SUTHERLAND SHIRE COUNCIL ASSESSMENT REPORT

Panel Reference	2019SSH003
DA Number	DA19/0021
LGA	Sutherland Shire Council
Proposed Development	Demolition of existing structures and construction of a mixed use development containing 42 units with stratum subdivision
Street Address	Lot 4 Sec 1 DP 1688, Lot 2 Sec 1 DP 1688, Lot 3 Sec 1 DP 1688, Lot 1 Sec 1 DP 1688, 1-7 Boyle Street, Sutherland.
Applicant	Vic Lake Architects
Date of DA lodgement	15.01.2019
Number of Submissions	Six
Recommendation	Approval
Regional Development Criteria (Schedule 7 of the SEPP (State and Regional Development) 2011	The development has a capital investment value of more than \$30 million and as such is nominated under Schedule 7 "Regionally significant development" of SEPP (State and Regional Development) 2011. The applicant's submission indicates that the proposed development has a value of \$30,149,671.00.
List of all relevant s4.15(1)(a) matters	<ul style="list-style-type: none"> • State Environmental Planning Policy (State and Regional Development) 2011 • State Environmental Planning Policy No. 65 (Design Quality of Residential Flat Development) • State Environmental Planning Policy No. 55 (Remediation o

Figure 7: SSDCP2015 20m building envelope (coloured in tan) variations – South elevation (Boyle St).

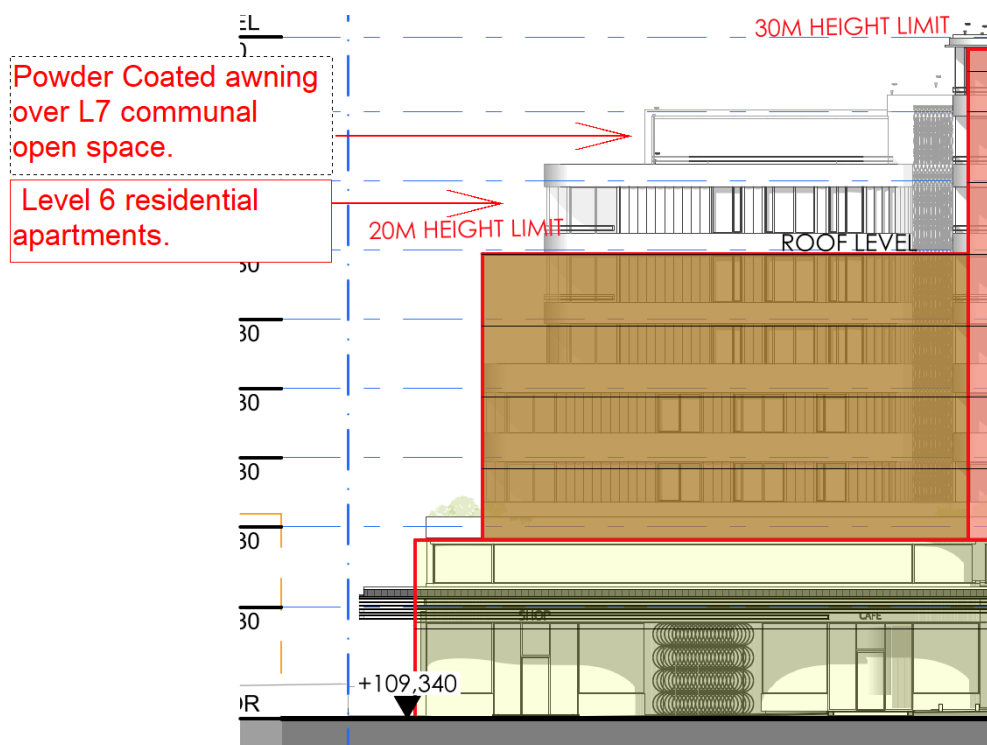
The 3 components are contained within the prescribed building envelope with the exception of the north-western tower exceeding the 20m height limit by 6.1m (a 30.5% variation to the DCP control). The non-compliant element relates to residential level 06, and the awning over the communal open space on level 07. An elevation of the variation (as viewed from Boyle St) is illustrated below:

Figure 8: Building Envelope & GFA comparison diagram- Level 05. The red line indicates the DCP building envelope, the blue line indicates the setback required under the ADG.

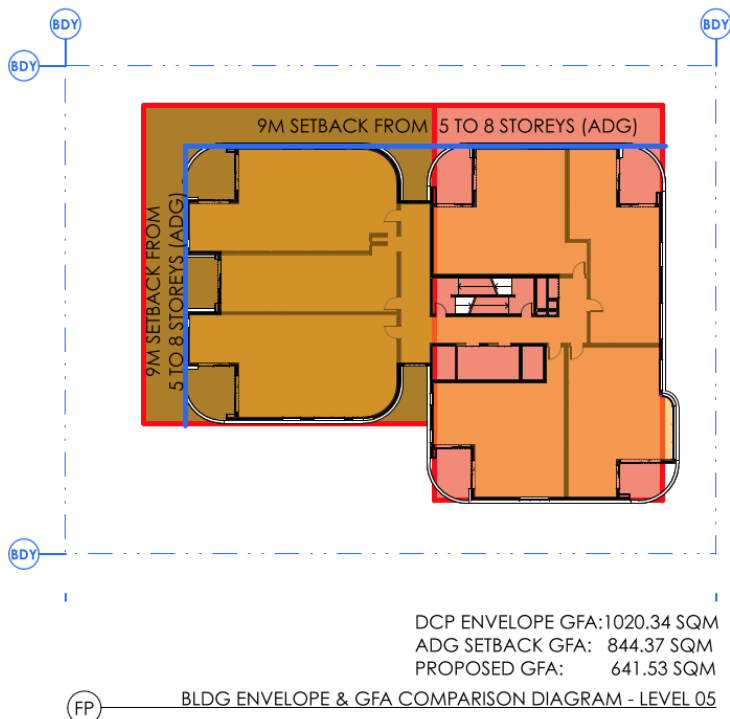
As discussed in section 10.11 of this report, the building envelope was formulated based upon the subject site's gross area. The building envelope parameters do not appear to have considered the impact of the land dedications (which constitute over 700m² of the site) on the achievable yield. The DCP envelope also applies lesser setbacks than recommended under the ADG. Figure 8 below illustrates the difference between the 4m setbacks to the boundary with Mccubbens lane prescribed by the DCP envelope control (red line), in comparison with the 6m (or 9m to the centreline of the lane) recommended under the ADG:

When applying the primary development controls, including height, FSR and ADG setbacks, a compliant building cannot fit within the DCP building envelope. A unique situation has been created whereby the DCP envelope does not successfully co-ordinate the primary development controls, which is one of the key aims of a site specific building envelope.

Figure 9: shadow impact comparison between compliant, and non-compliant 20m tower element.

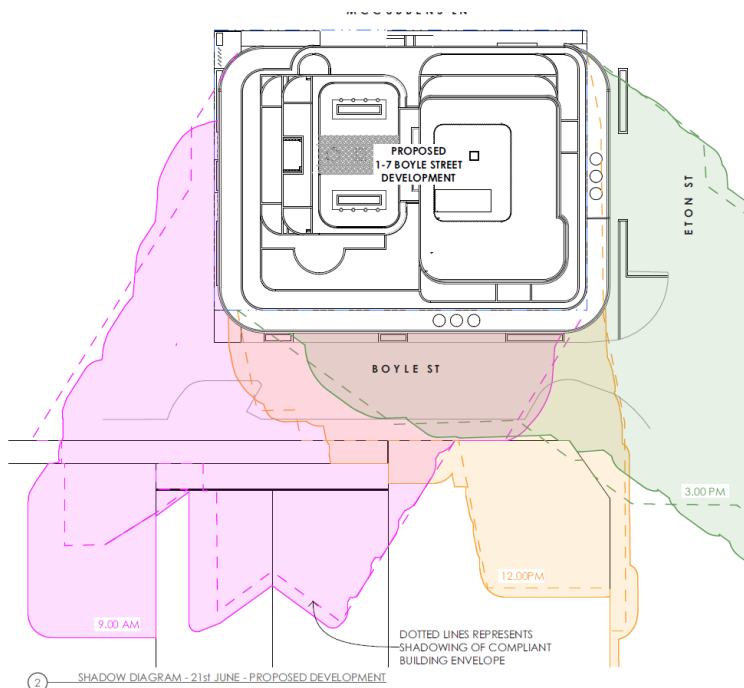
When reviewing the mid-winter shadow diagrams, it is apparent that the greater shadow impact is attributed to the taller 30m tower due to its closer position to the Boyle Street frontage and the sites orientation. As illustrated in Figure 9 below, the difference between the shadow from a compliant 20m tall building and the non-compliant 26.1m tall building (which is 50% composed of an open form awning with substantial boundary setbacks) on the public domain is minimal.

Figure 10: Level 02 variation to the 4m setback are related to the balcony space and articulation band as illustrated in yellow.

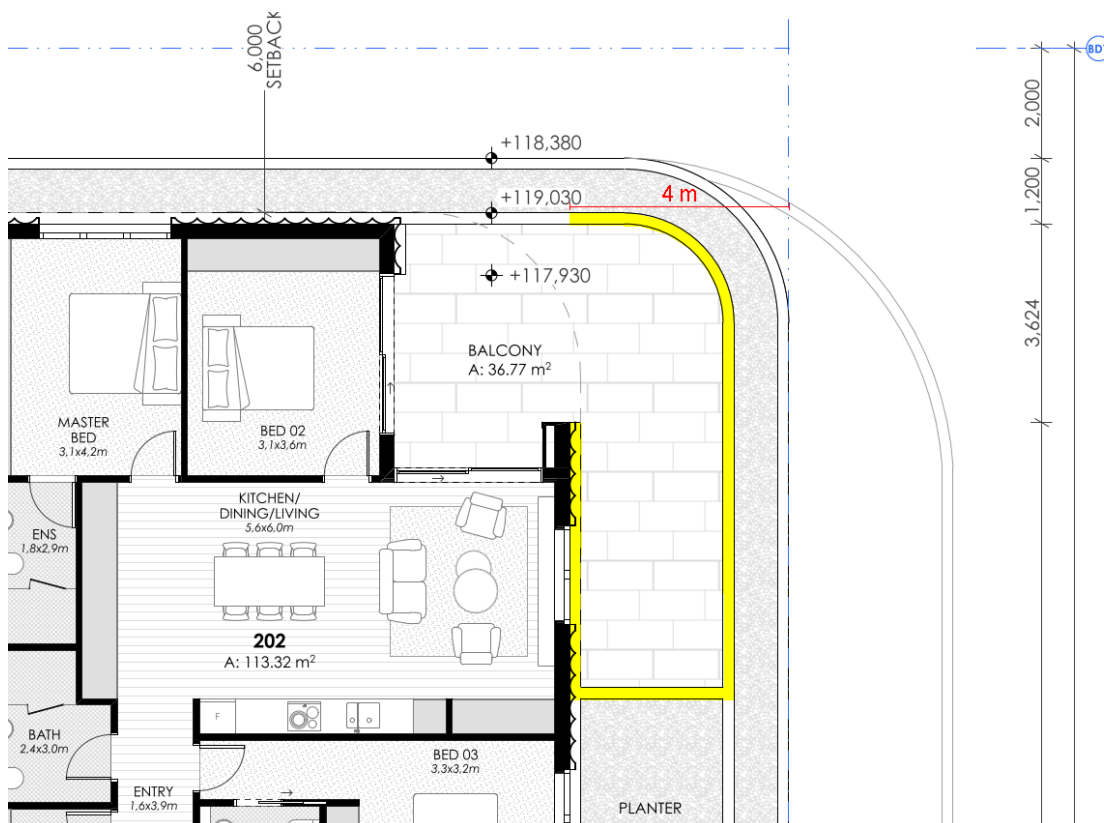
- Level 2 balcony associated with unit 202, 203 and 204, which is setback 1m from Eton and Boyle St;
- A portion of corner units (203, 303, 403, 503, 603, 703 and 802) positioned at a 3m setback;
- Articulation bands provided at a 2.8/3.8m setback.

The balcony protrusions into the setback are minor, and provide the benefit of increased amenity through the efficient use of the proposed concrete slab for private open space. The projections toward the Boyle/Eton Street corner create a visually interesting building through articulated elements, which address a prominent corner. The Eton/Boyle Street corner is central and a prominent feature in the locality, and the design response highlights this feature.

Figure 12: Relationship between blank wall of unit 207 and balcony of unit 201.

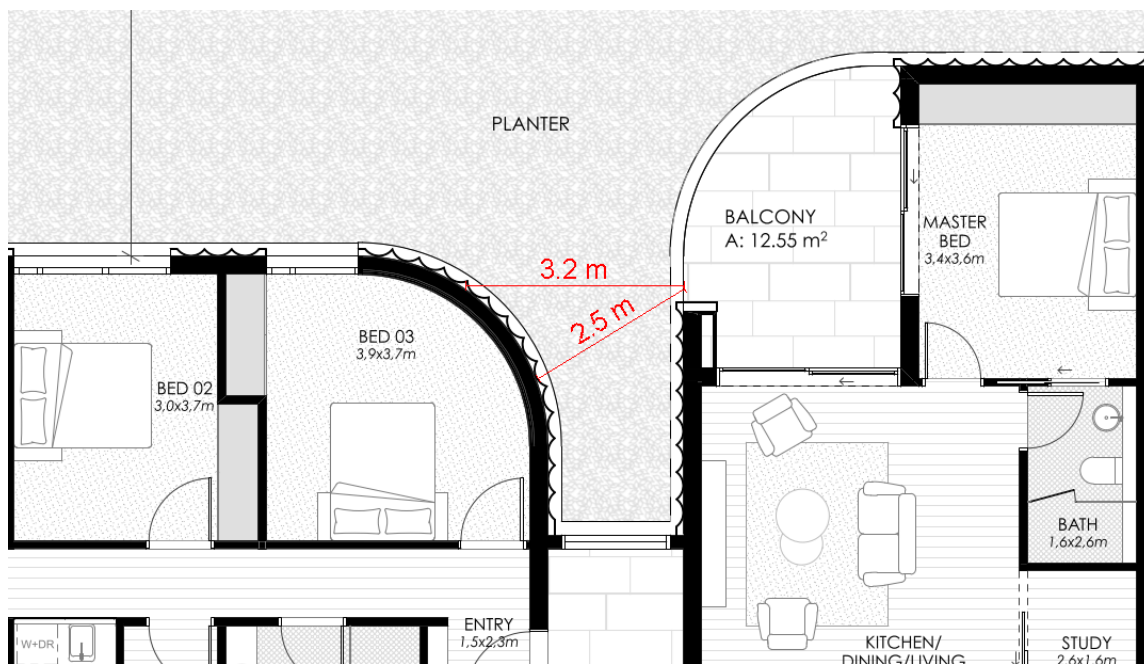
A 3.2m separation distance is provided between the unit 201 balcony and the blank wall associated with unit 207 which is repeated on level 3. When measuring from the closest point between the two buildings (diagonally) the separation distance reduces to 2.5m. An example of this relationship is illustrated at Figure 12 below:

The non-compliant section affects a small 0.8m length of the balcony, before the buildings peel away from each other. Given the staggered position of the buildings, and the dual aspect of the balconies, the unit 201/207 interface, replicated on level 3, will not compromise privacy or access to light, and is acceptable.

Figure 13: Relationship between unit 305(left) and unit 304(right)).

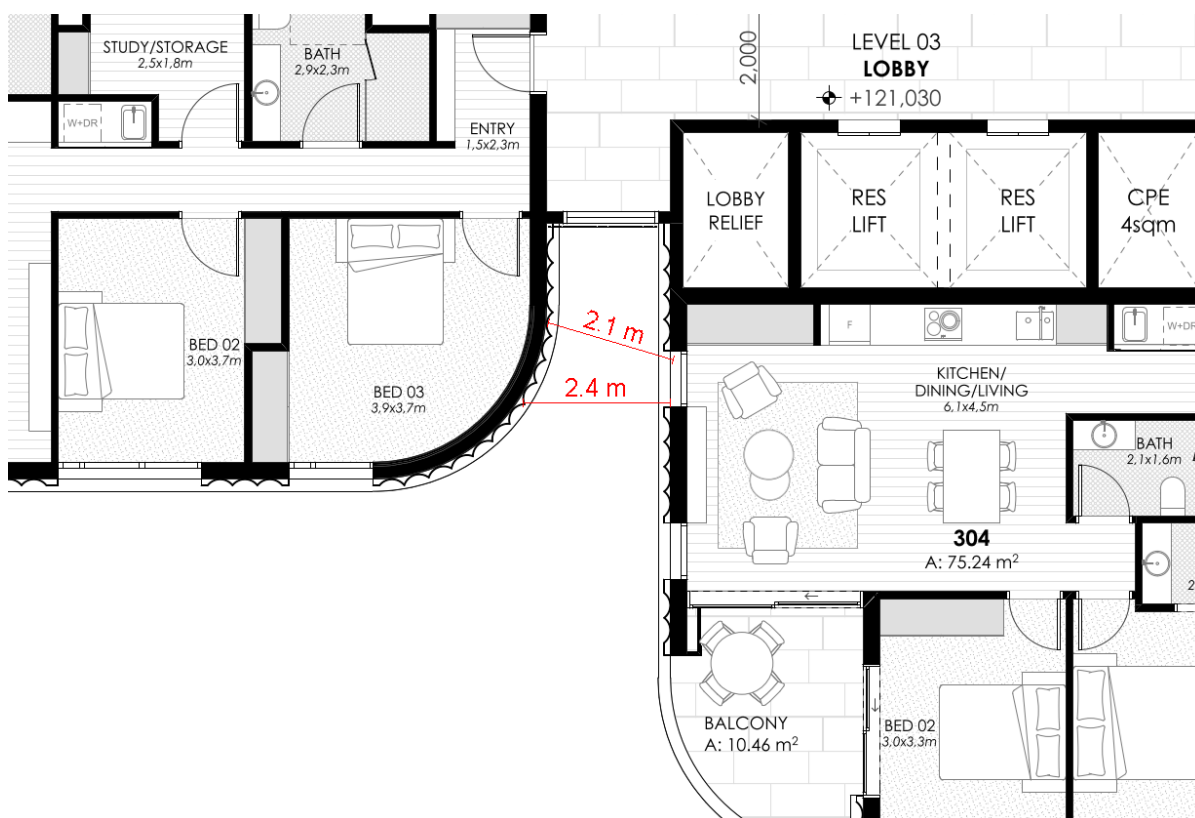
A 2.4m separation distance is provided between one of the unit 204 living room windows and the bedroom wall of unit 205. When measuring from the closest point between the two buildings (diagonally) the separation distance reduces to 2.1m. The non-compliant element resolves when the unit 205 wall curves away from unit 204. This relationship is repeated on each level up to level 6. An illustration of this relationship is provided at Figure 13 below:

The designer has addressed the non-compliances by offsetting windows, orienting apartments in different directions, and providing additional windows to compensate living spaces with multiple sources of light from different aspects. The balconies are positioned at an oblique angle to the bedroom windows, limiting overlooking.

Figure 14: Relationship between unit 205(left) and unit 204(right) balconies, and recommended amendments.

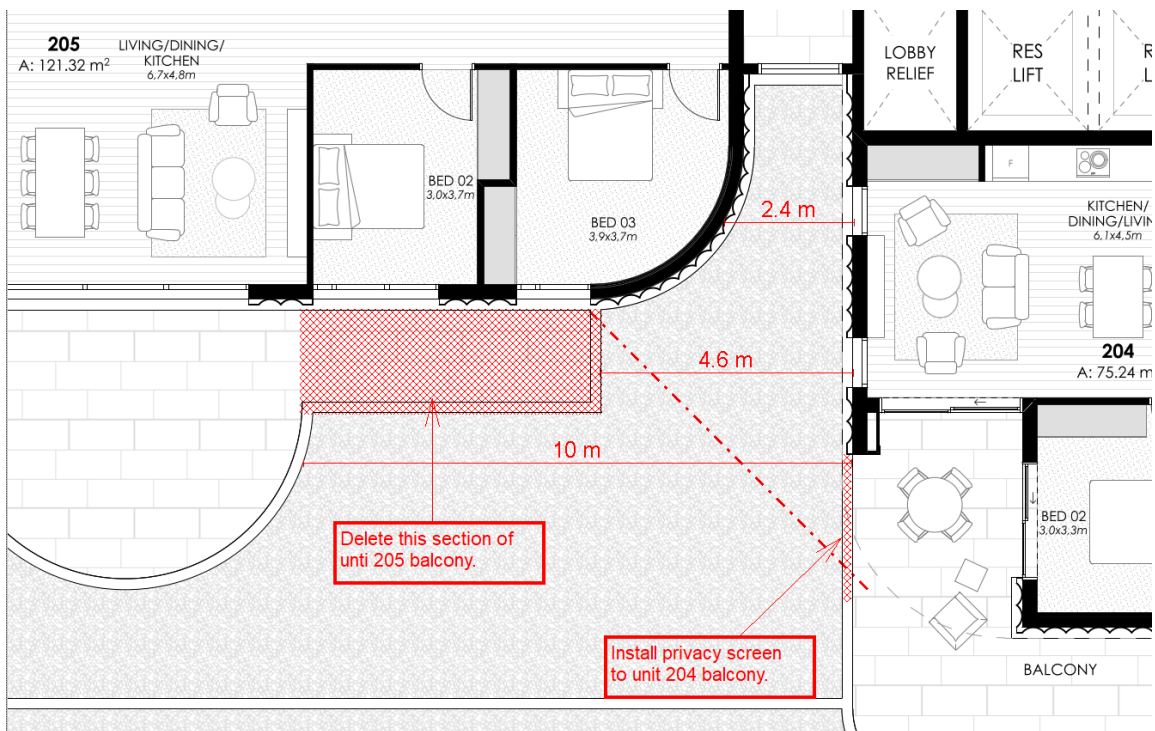
The Revision C plans have also introduced a larger balcony to service unit 205 which is 4.6m from the opposing unit 204 living room window, and the unit 204 balcony. This relationship is not replicated on the levels above. Under the above conditions, the ADG recommends a 12m separation distance. To address the deficiency, a condition of consent is recommended to delete the eastern portion of the unit 205 balcony. A privacy screen is also recommended to be attached to the western elevation of the unit 204 balcony. The changes are marked on Figure 14 below.

Subject to the recommended design change conditions, the proposed building separation does not compromise amenity to adjoining land, or within the development itself. The variations are a result of the building being articulated into separate components, rather than for example, a literal interpretation of the building envelope control where the building could comprise long unarticulated “boxes”. The design response provides a more interesting building whilst maintaining amenity to units, despite small portions of the building not strictly complying with the ADG separation distances. Compliant apartment sizes, solar access and natural ventilation have been achieved. The proposal provides good overall amenity to each unit, and the above variations are supported.
